SUPPLEMENT

IN RESPONSE TO CEC DATA ADEQUACY REVIEW APPLICATION FOR CERTIFICATION (09-AFC-01)

for Watson Cogeneration Steam and Electric Reliability Project

June 2009

Figure 5.6-1 (Revised)
CNDDB Sensitive Species and Vicinity Map

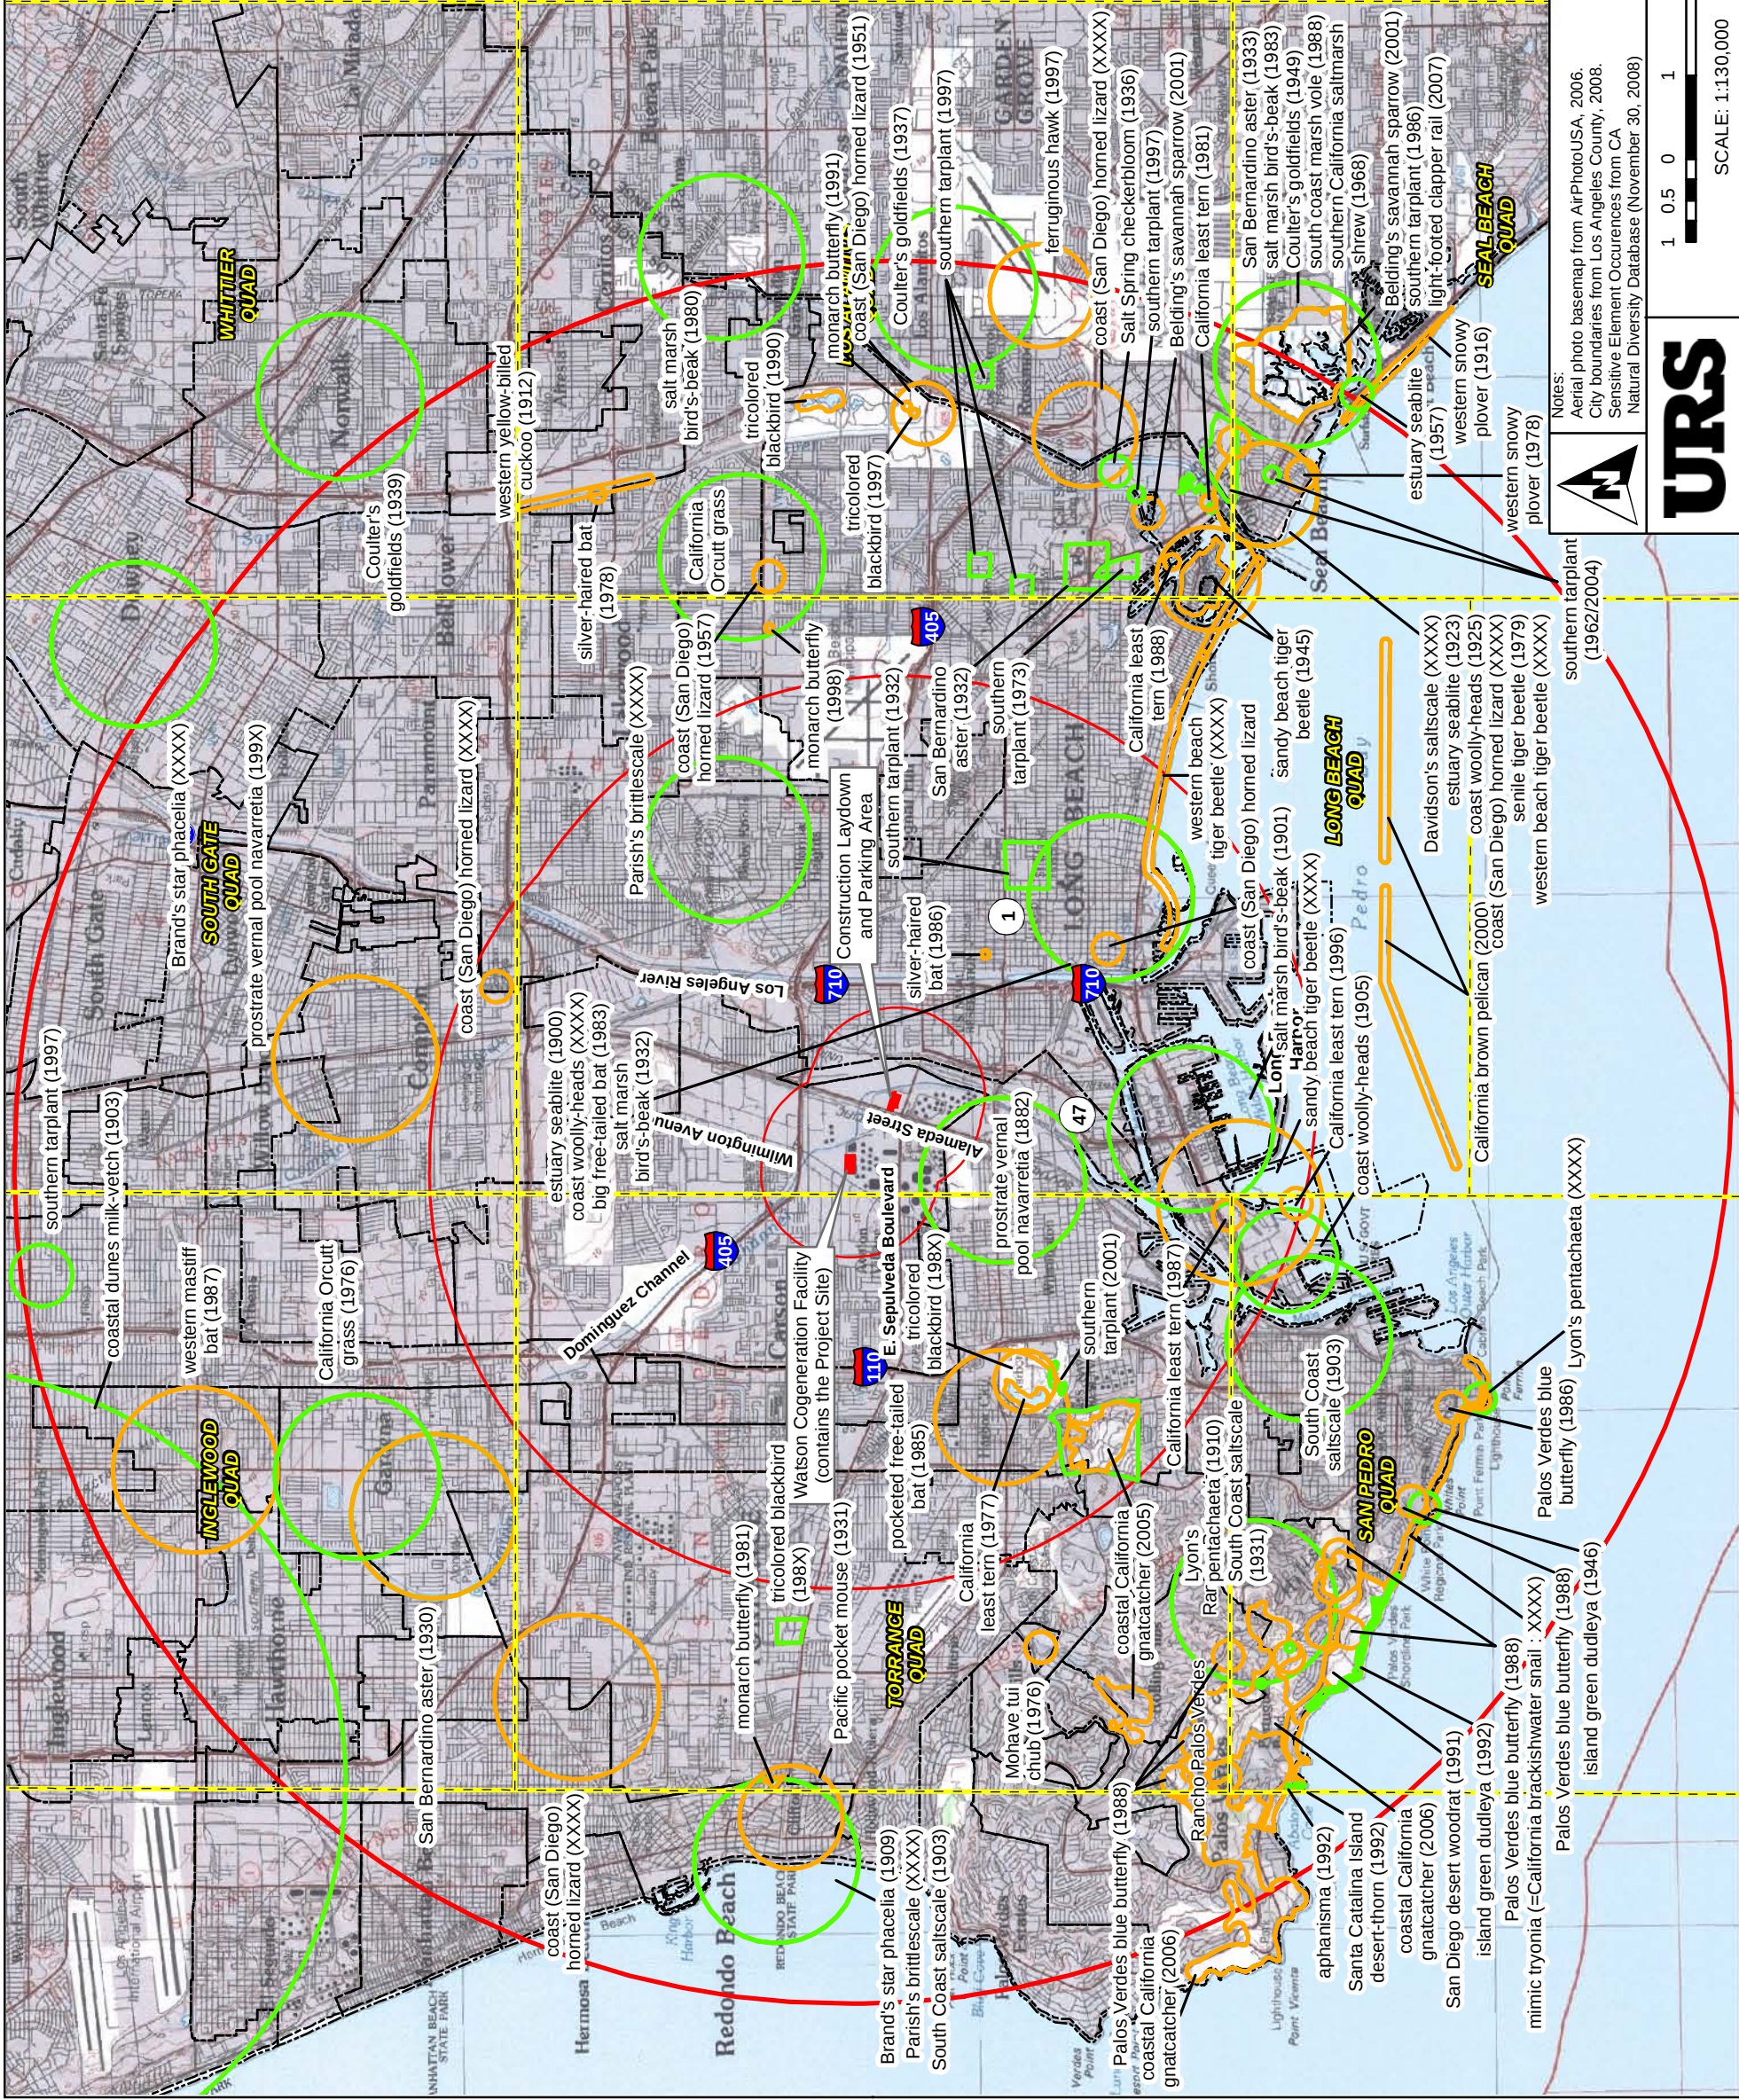
2b	Appendix B (g) (13) (A) (i)	species listed under state or federal Endangered Species Acts;	Please include species listed under the state or federal Endangered Species Acts within ten (10) miles of the project.	The species listed under the state or Federal Endangered Species Acts within 10 miles of the Project are shown on Figure 5.6-1 (Revised) and listed in Table 5.6-1 (Revised) located in Appendix B of this AFC Supplement.
2c	Appendix B (g) (13) (A) (ii)	resources defined in sections 1702(q) and (v) of Title 20 of the California Code of Regulations;	Please include areas of critical and special concern within ten (10) miles of the project.	Areas of critical and special concern within 10 miles of the Project are shown on Figure 5.6-1 (Revised) located in Appendix B of this AFC Supplement.

Figure B-1
Project Site and Survey Area

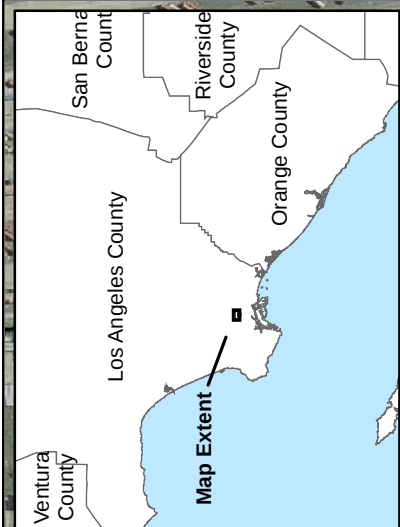
COMMENT NUMBER	SITING REGULATIONS	INFORMATION	INFORMATION REQUIRED TO MAKE AFC CONFORM WITH REGULATIONS	RESPONSE
2h	Appendix B (g) (13) (B) (i)	Detailed maps at a scale of 1:6,000 or color aerial photographs taken at a recommended scale of 1 inch equals 500 feet (1:6,000) with a 30 percent overlap that show the proposed project site and related facilities, biological resources including, but not limited to, those found during project-related field surveys and in records from the California Natural Diversity Database, and the associated areas where biological surveys were conducted. Label the biological resources and survey areas as well as the project facilities;	Please include a detailed map at a scale of 1:6,000 that shows the project site and biological resources, including those found during surveys and in records from the California Natural Diversity Database.	New Figure B-1 (in Appendix B of this AFC Supplement) shows a detailed map of the Project Site and survey area at a scale of 1:6,000. No biological resources were identified in the area.

Figure 5.9-3 (Revised)
Zoning

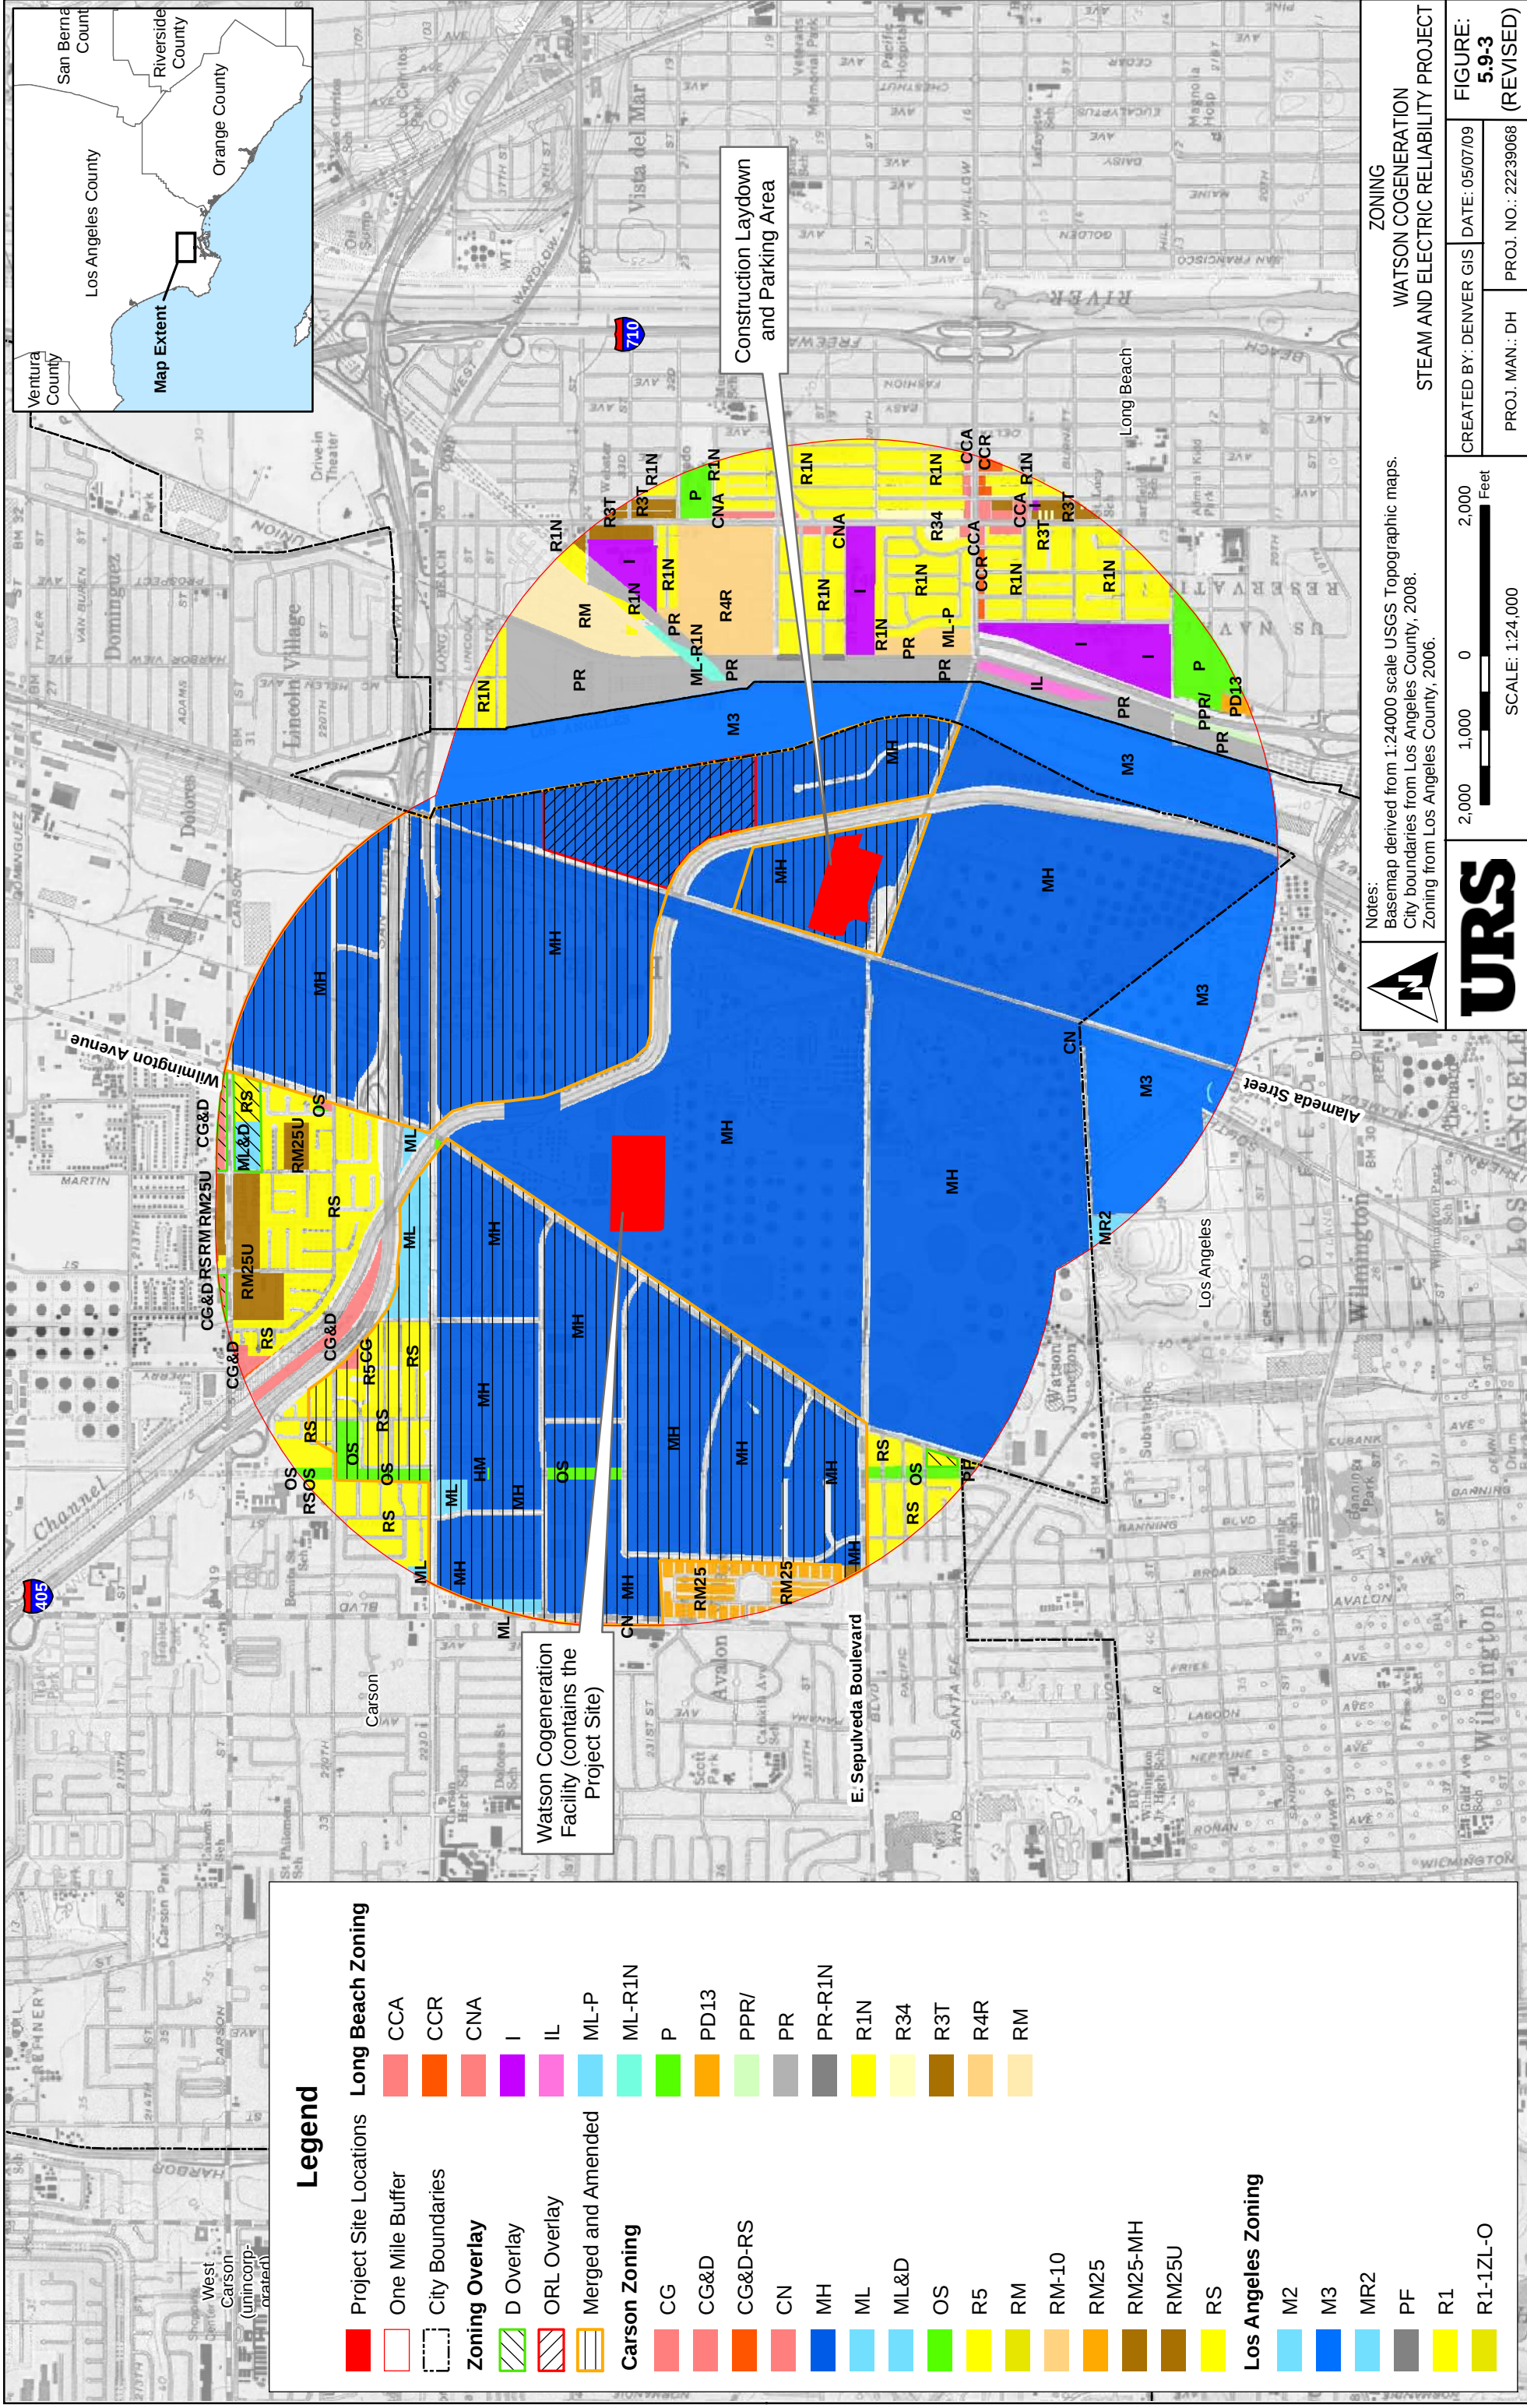
COMMENT NUMBER	SITING REGULATIONS	INFORMATION	INFORMATION REQUIRED TO MAKE AFC CONFORM WITH REGULATIONS	RESPONSE
3	Appendix B (g) (3) (A) (iv)	Legible maps of the areas identified in subsection (g)(3)(A) potentially affected by the project, on which existing land uses, jurisdictional boundaries, general plan designations, specific plan designations, and zoning have been clearly delineated.	Please provide a legible map with general plan designations for the areas potentially affected by the project.	A new figure (Figure C-1) has been provided in Appendix C of this AFC Supplement to present planned land use. As a result of the new figure, the title of the original AFC Figure 5.9-3 has been changed from "Zoning and Planned Land Use" to "Zoning" and is presented as Figure 5.9-3 (Revised) in Appendix C of this AFC Supplement.
